**Re: Proposed development of Cavan Town Sports Campus
in the townlands of Kilnavara, Lurganboy (Loughtee Upper By), Creighan and Rosscolgan in Cavan
Town.**

R.E. Application to An Bord Pleanála for approval under Sections 175 and 177AE of the Planning and Development Act 2000 (as amended) and the Planning and Development Regulations 2001 (as amended) by Cavan County Council for Cavan Regional Sports Campus

Figure 1 - Extract from Site Location Map A2156-100-02. Our house and property is outlined in green

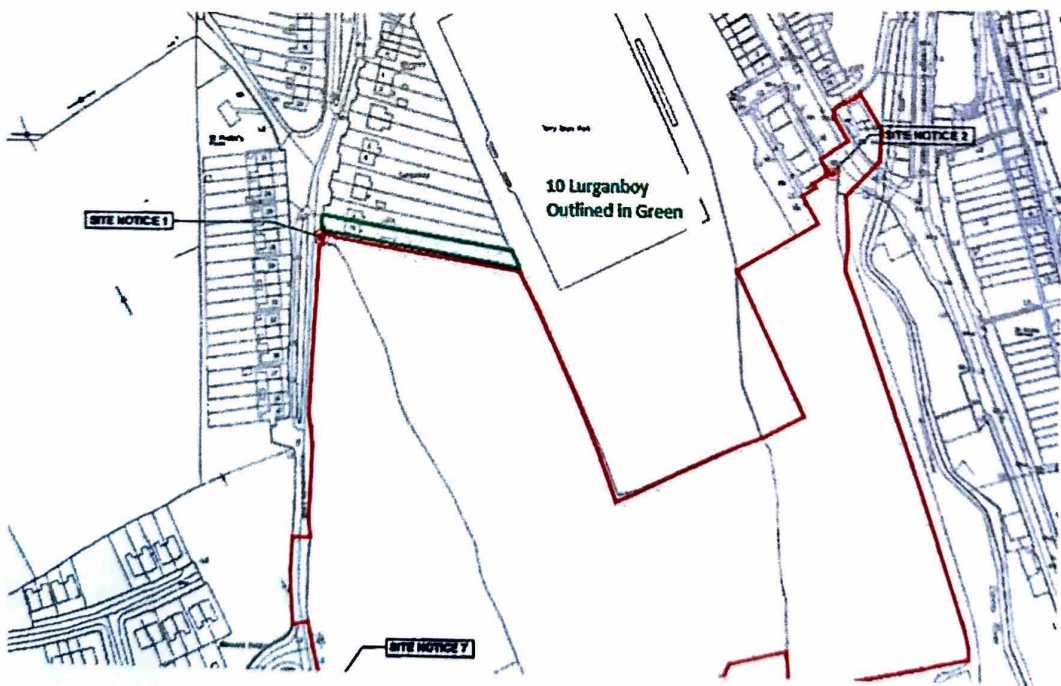
We are the property owners of 10 Lurganboy, Cavan, H12 W012 . Our property is the last house on the Eastern side of Kilnavaragh Lane and will bound the proposed new development's North-Western boundary for circa 85m, along the entirety of our Southern boundary.

Figure 2 - Extract from A2156-100-10 - Tower flood light locations.

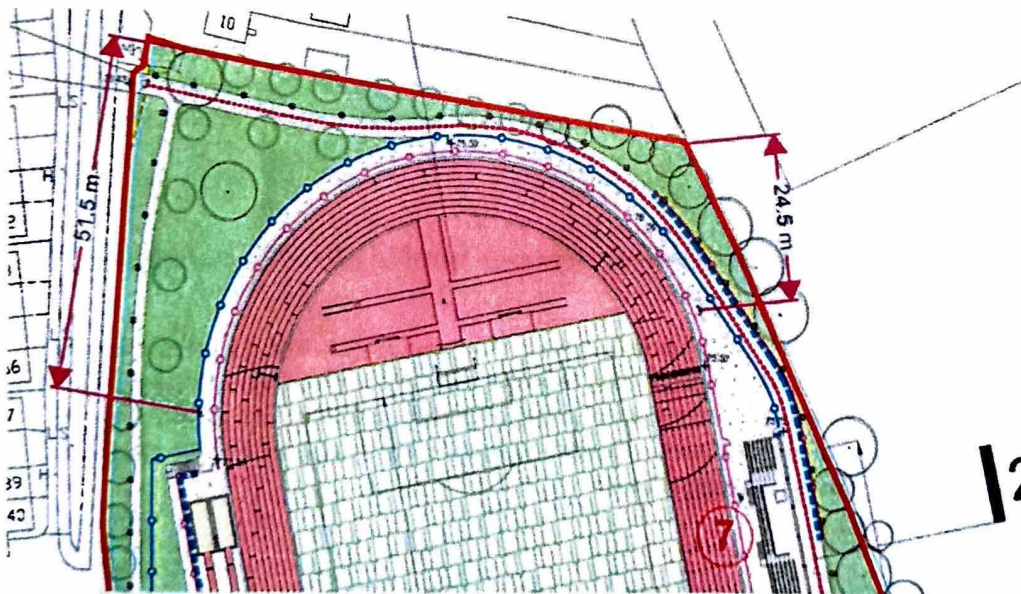
It is also noted that the layout drawing A2156-100-11 shows three number lighting columns along each of the longitudinal sides of the running track, however the 9955-JCP-ZZ-00-DR-E-63003-P02 drawing shows lighting columns at each end of the running track, roughly six (6) metres from our boundary. It is not clear which set of locations were used to assess the flood lighting design (if there is any) and impacts of same as part of the EIAR.

Figure 4 - Extract from A2156-100-11. Section 1B location

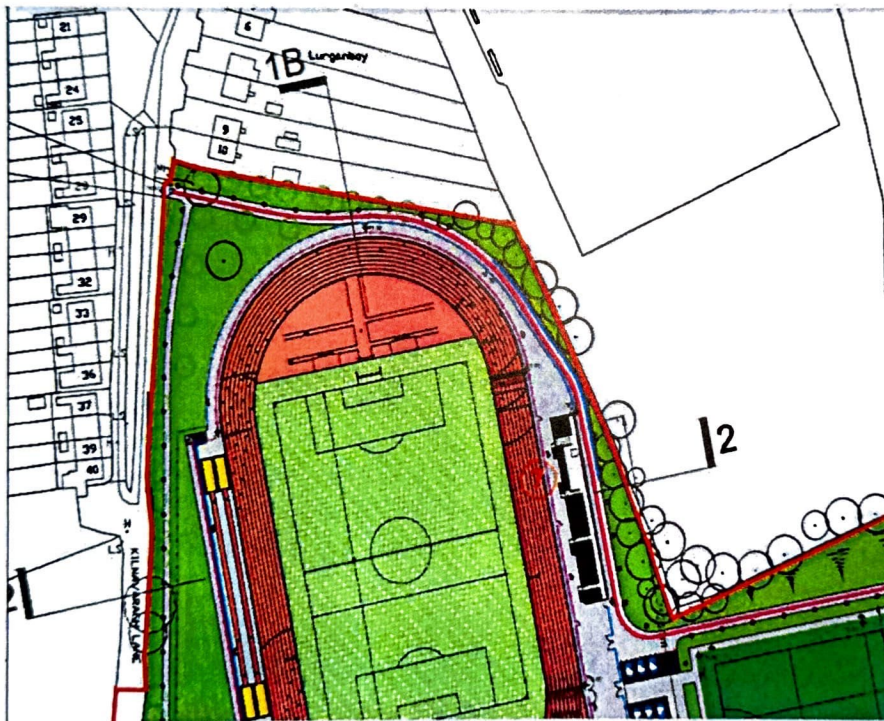
2. Accuracy of information. Some information within the EIAR do not appear to be accurate. For example, the section line shown on drawing A2156-100-11 showing section line 1B and the corresponding section 1B on drawing csc-mca-xx-zz-dr-a-4101, do not allow for an appreciation of the impact of the levels, size and scale of the development adjacent to my property.

It is not possible to assess the visual impact of the development as the drawings are not consistent with each other. The general layout drawing, A2156-100-11, shows the location of section line 1B, extending through a number of properties to the north. The section line is facing Kilnavaragh lane. Drawing CRSP-MCA-00-00-DR-C-1800-P1 shows earthworks cut and fill levels, moving from cut to fill north to south across the location of section line 1B. The sections provided however are not along section 1B as it does not correlate with the earthwork cut and fill levels, does not show any boundary walls, does not show fence lines, pathways, pitch boundaries, floodlight towers etc. It is also questioned what building is shown on 1B of csc-mca-xx-zz-dr-a-4101, as the elevation and scale of the spectator stand does not match that of csc-mca-xx-xx-dr-A-2005.
